N279 UPS13518-1BNAS1

# TECHNICAL BULLETIN

Update Prior to Sale: SV-Autobiography - Bumper Blanking Plate

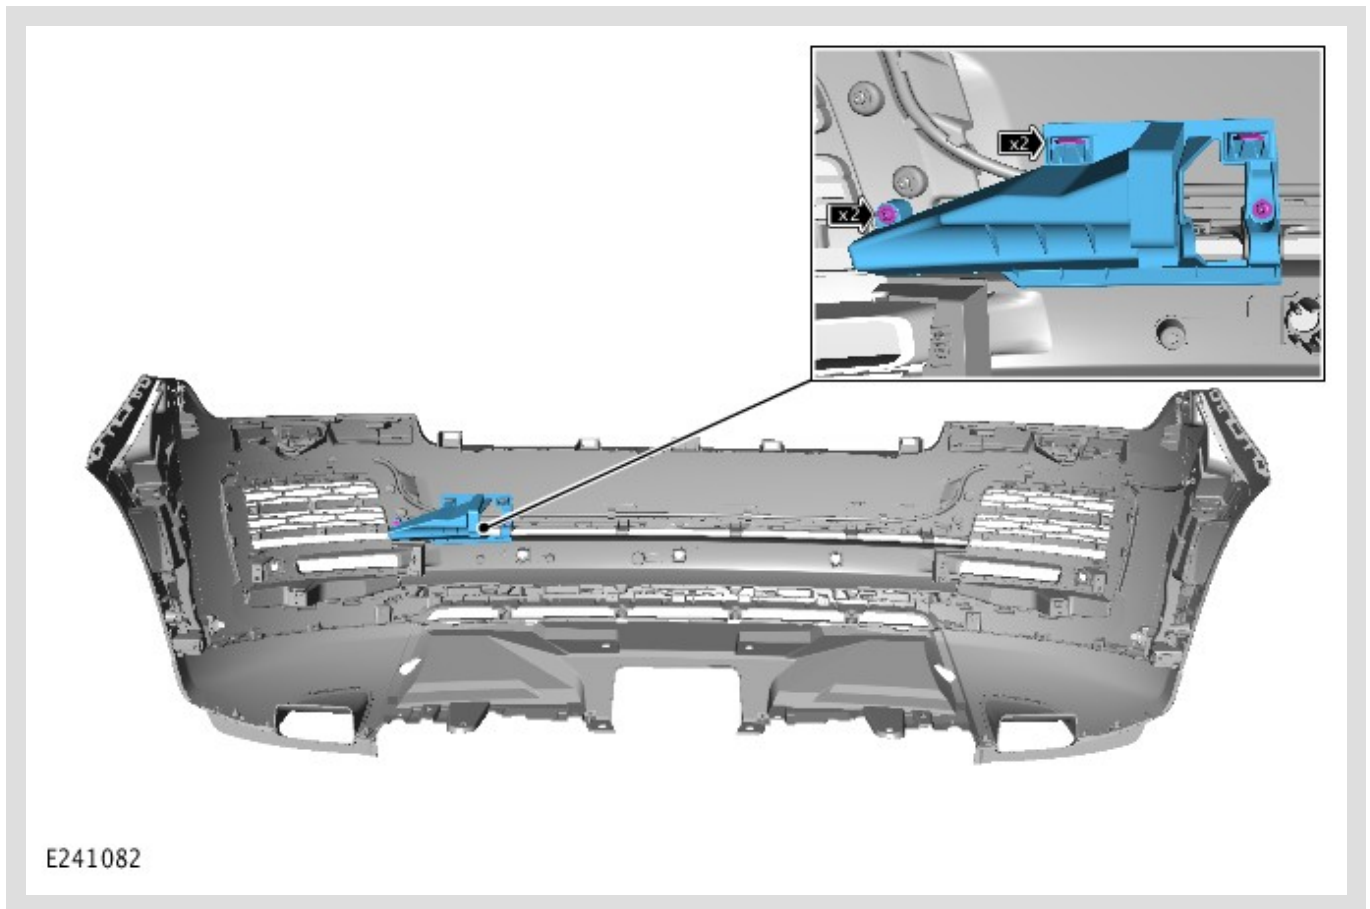
A potential issue has been identified on a limited number of Land Rover vehicles within the listed Affected Vehicle Range may have a front bumper with a blanking plate installed when not required, which could lead to the vehicle overheating.

Remove and discard the front bumper blanking plate.
